[Docket No. FAA-2023-1407; Project Identifier MCAI-2023-00788-T; Amendment 39-22501; AD 2023-14-01]

**Airworthiness Directives; Bombardier, Inc., Airplanes**

**ACTION:** Final rule; request for comments.

Figure 1 to Paragraph (g)(2)(i)—  
 Fundamental Effective Isotropic PSD at  
 Outside Interface of Aircraft Antenna

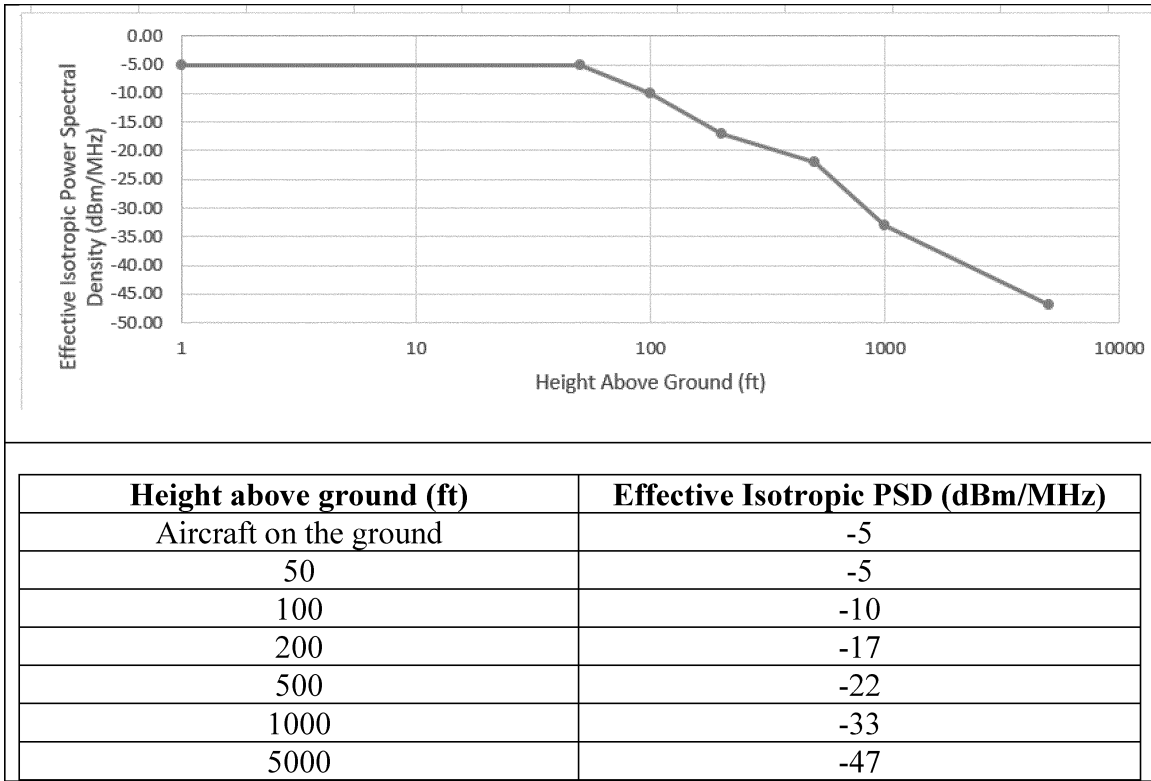
(i) Tolerance to radio altimeter interference, for the fundamental emissions (3.7-3.98 GHz), at or above the power spectral density (PSD) curve threshold specified in figure 1 to paragraph (g)(2)(i) of this AD.

Figure 2 to Paragraph (g)(2)(ii)—Spurious Effective Isotropic PSD at Outside Interface of Aircraft Antenna

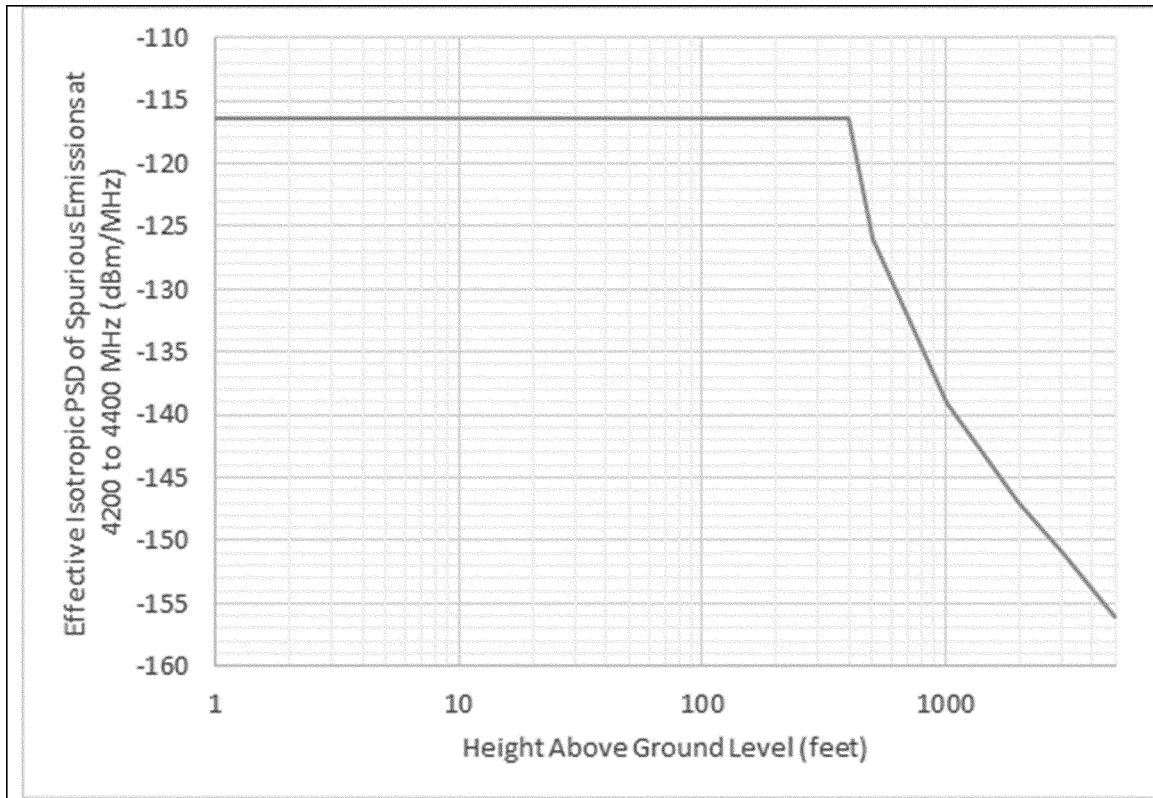
(ii) Tolerance to radio altimeter interference, for the spurious emissions (4.2–4.4 GHz), at or above the PSD curve threshold specified in figure 2 to paragraph (g)(2)(ii) of this AD.

<u>Aircraft Altitude (ft AGL)</u>	<u>Effective Isotropic PSD (dBm/MHz)</u>
1	-116.50
400	-116.50
500	-126.00
1000	-139.00
2000	-147.00
3000	-151.00
5000	-156.00
